Section 7: Spent Fuel Pool Integrity Evaluation

7.1 Scope of the Seismic Evaluation for the SFP

Figure 7-1
Basic Process for Evaluation of Potential Failures for SFP Penetrations

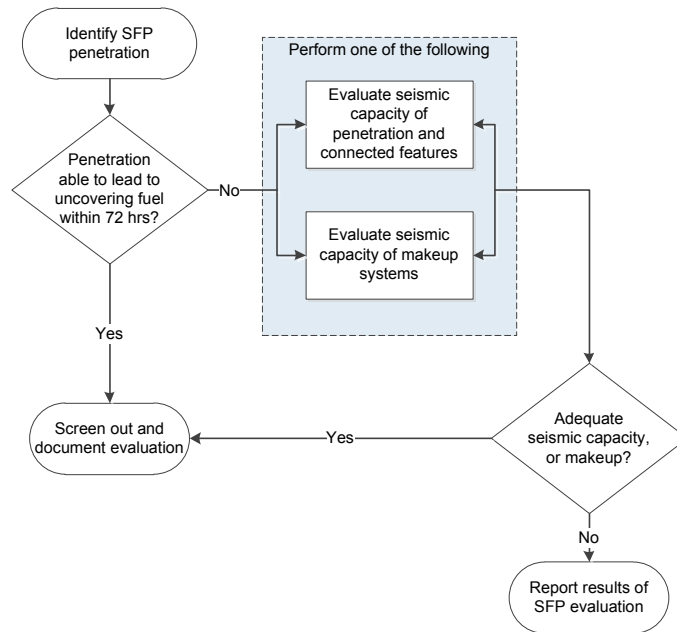
1. Those that are above the level of the fuel in the SFP;
- ~~2. Those that are at a level below the top of the fuel in the SFP; and~~
- ~~2. Those that are above the level of the fuel in the SFP; and~~
3. Those that may have the potential to siphon water from the SFP (most typically, the discharge line from the SFP cooling system).

7.2.2~~1~~ Evaluation of Penetrations below Top of Fuel

The SFPs for plants operating in the United States are generally configured so that they do not have penetrations below the top of the stored fuel. The absence of penetrations lower in the pool inherently limits the potential to drain inventory sufficiently to begin uncovering fuel. It is possible; however, that some SFPs may have penetrations (e.g., drain lines) below the top of the stored fuel assemblies. ~~Moreover, while the transfer gates opened when moving fuel into and out of the SFP typically extend down to relatively near the top of the stored fuel, there may also be some SFPs for which the bottom of the transfer gates is below the top of the fuel. A failure associated with such a penetration could drain the pool level below the top of the fuel if there were inadequate~~

makeup flow to the pool. A process for evaluating connections to the SFP with penetrations below the top of the fuel is outlined in Figure 7-1.

The evaluation should confirm that the makeup systems have adequate seismic capacity to address the needs for restoring and maintaining SFP inventory. ~~The first step is to determine whether a failure of system connected through the penetration in question could drain water from the pool at a rate sufficient to lead to uncovering of the fuel within 72 hours. Note that, for a typical SFP, even an opening with an effective diameter of 1 in. at or near the bottom of the SFP could result in a drainage flow rate, at least initially, on the order of 100 gpm. For a nominal SFP containing approximately 400,000 gal, such a flow rate would be sufficient to lower level to below the top of the fuel within about 50 hours. Therefore, only very small penetrations could be eliminated based solely on the length of time it would take to lower the level in the pool below the top of the fuel.~~

~~If the failure of interest is that of a fuel transfer gate, the time it would take to drain down to the top of the fuel could be substantially less than 72 hours.~~

~~Thus, the first step may be irrelevant for all but the smallest potential penetration failures. These very small penetrations should be screened from further analysis on the basis of the very long time it would take to drain the SFP to the top of the irradiated fuel. The evaluation of the penetrations should be documented for future reference.~~

~~If the penetration cannot be screened out, the next step is to determine whether provisions to make up to the SFP following an earthquake are sufficient to keep the fuel cooled. Two primary elements need to be considered together in performing this part of the evaluation:~~

Figure 7-2
 Basic Process for Evaluation of Potential Siphoning of SFP Inventory

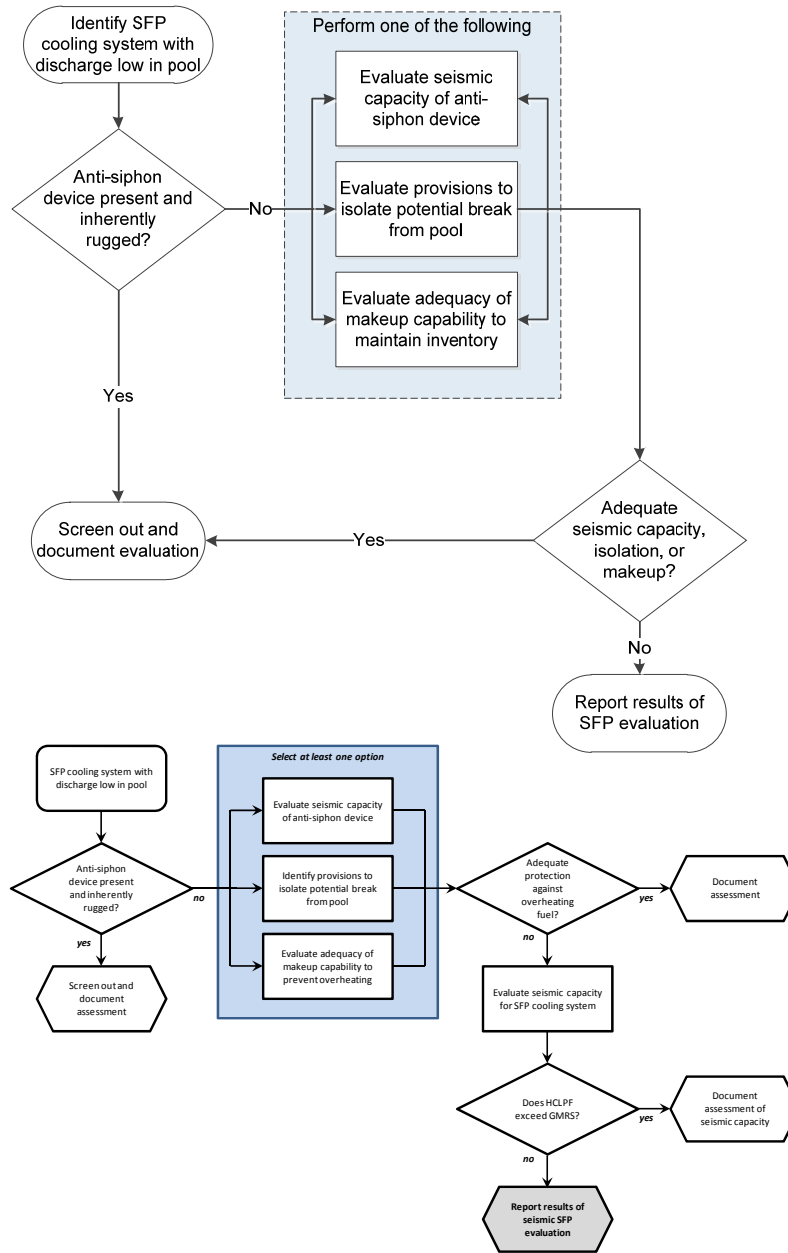
Although designs differ from plant to plant, for some SFPs the discharge line from the SFP cooling system extends down into the pool. Cool water is introduced low in the pool, and the suction line takes warm water from closer to the top of the pool. If the SFP cooling system were to experience a failure, it is possible that water could be siphoned back through the discharge line and out the break. To prevent such an occurrence, SFP cooling systems with this configuration are typically equipped with anti-siphon devices. If the anti-siphon device were to function improperly, the effect ~~could essentially be similar~~ ~~equivalent~~ to a break below the top of the fuel, as addressed in Section 7.2.24. ~~Thus, the process for evaluating failures in the SFP cooling system that might lead to siphoning inventory from the pool is outlined in Figure 7-3.~~

The anti-siphon devices are expected to be relatively rugged; for purposes of this evaluation, an evaluation should be ~~performed~~ ~~made~~ to confirm that, if such a feature is needed to prevent siphoning water from the pool. If there are questions about the ruggedness of the feature, the evaluation may follow one of three paths, depending on what information is most readily available:

~~Note that, even if the break in the SFP cooling system could stop the loss of inventory from the SFP, it would still be necessary eventually to establish makeup to the SFP because of the interruption of the cooling function.~~
